NFPA 805 OBSERVATION VISIT TRIP REPORT

Date: January 7 – 8, 2008

Subject: Observation Visit for Pilot Plants Transitioning to National Fire Protection Association (NFPA) 805, "Performance-Based Standard for Fire Protection for Light Water Reactor Electric Generating Plants."

Figure 1. Multiple Spurious Post-Transition Inspections

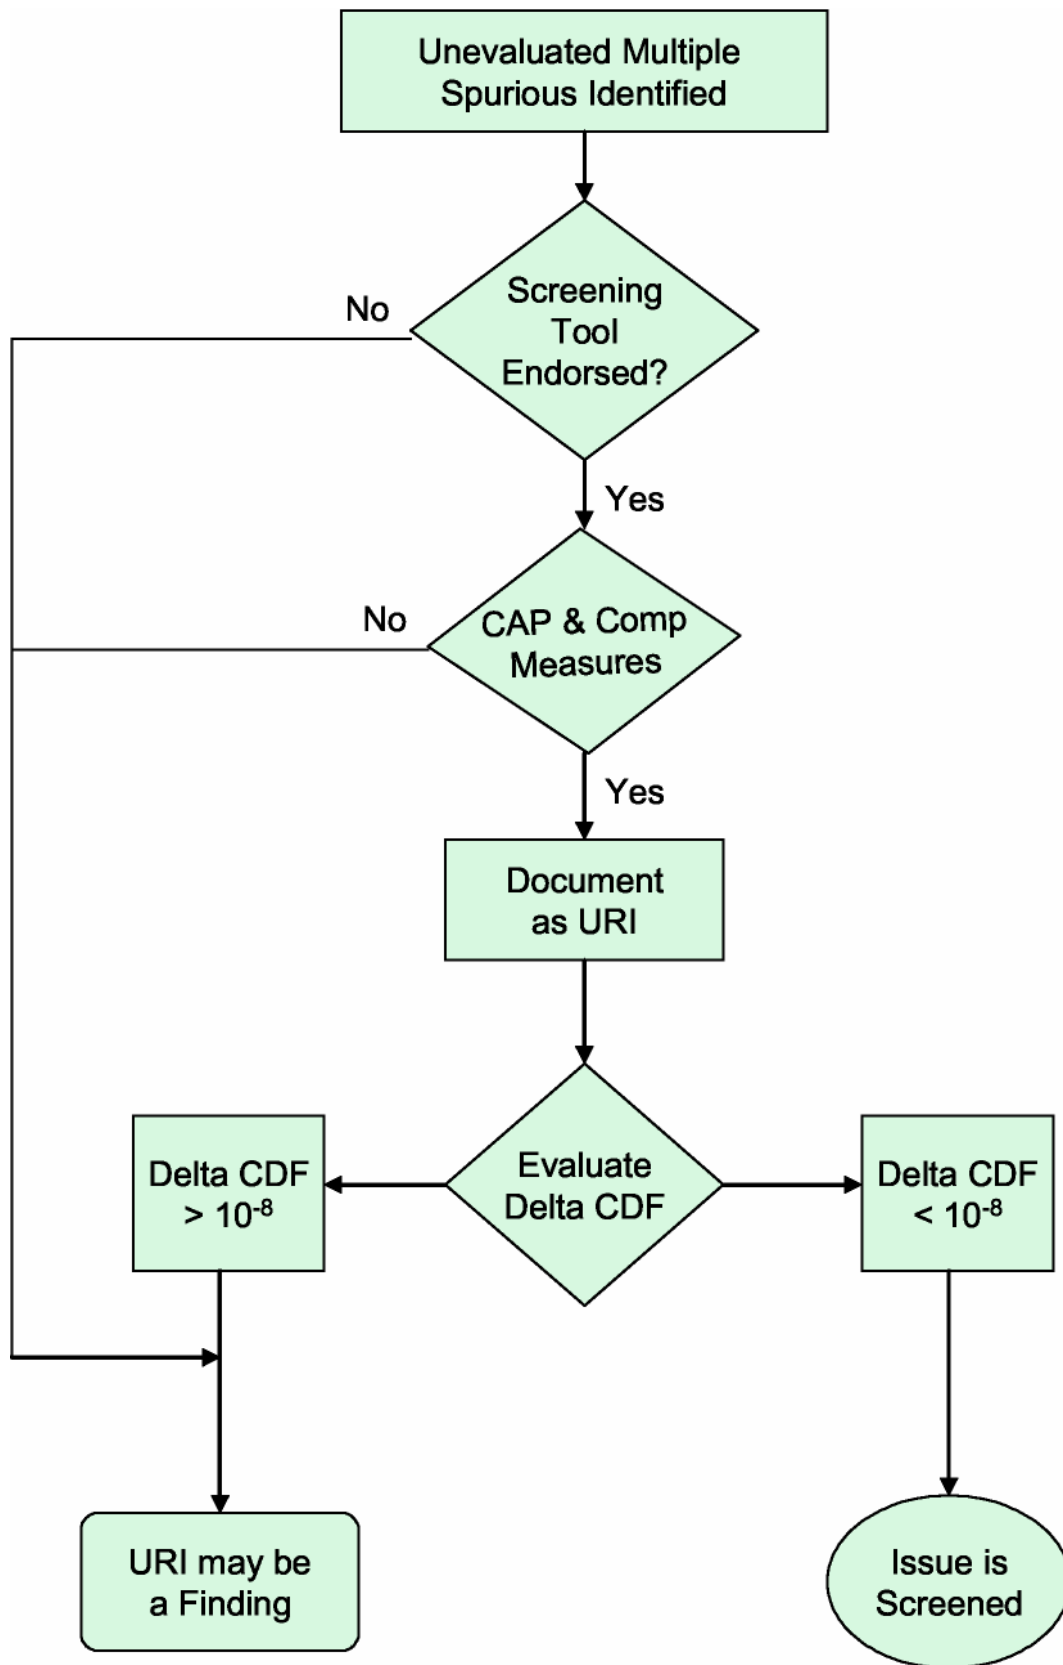
Status: OPEN. The November 2005 pilot-plant observation visit initially identified this issue. The NRC Staff reviewed the ROP relative to the treatment of newly identified multiple spurious operations that have unknown risk significance.

At the March 2006 pilot plant observation visit, the Staff presented a flow chart, illustrating how newly found multiple spurious circuits identified during an inspections, could be treated (See flow chart below). In addition to the flowchart, the following information was discussed:

Resolution Action(s)/Action Party: OPEN. Industry and pilot-plant participants agreed to review the flowchart, IMC 0612 questions, screening thresholds and provide feedback to the NRC at the next observation meeting. The industry may also submit an FAQ on the issue.
